# COMMUNITY HOUSING REDEVELOPMENT PROGRAM (CHRP) 25 – 27 EASTON AVENUE, SYLVANIA NSW 2224

BUILDING CODE OF AUSTRALIA 2019 AMENDMENT 1 VOLUME TWO REPORT STAGE C

**FEBRUARY 2023**

Figure 3.7.3.2 Separating wall construction—Underside of non-combustible roof cladding

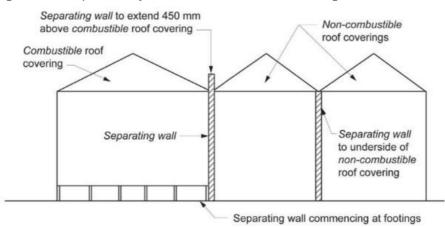
- (d) Where a building has a masonry veneer external wall, any gap between the separating wall so the external masonry veneer must be
  - (i) Not more than 50 mm; and

- (ii) Packed with a mineral fibre or other suitable fire-resistant material with the packing arranged to maintain any weatherproofing requirements
- (e) eaves, verandahs and similar spaces that are open to the roof space and are common to more than one Class 1 dwelling must be separated by a non-combustible vertical lining

#### Diagram a.

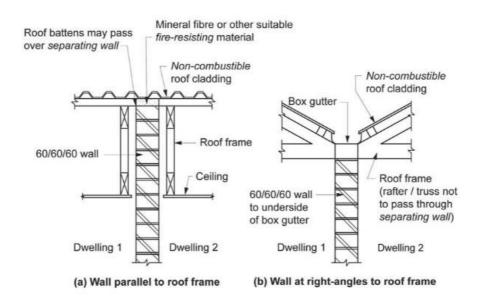
Compliance readily achievable and to be documented throughout design progression. Architect to note the requirements of separating construction above and provide details of the wall systems separating the townhouses from each other as highlighted in red below.
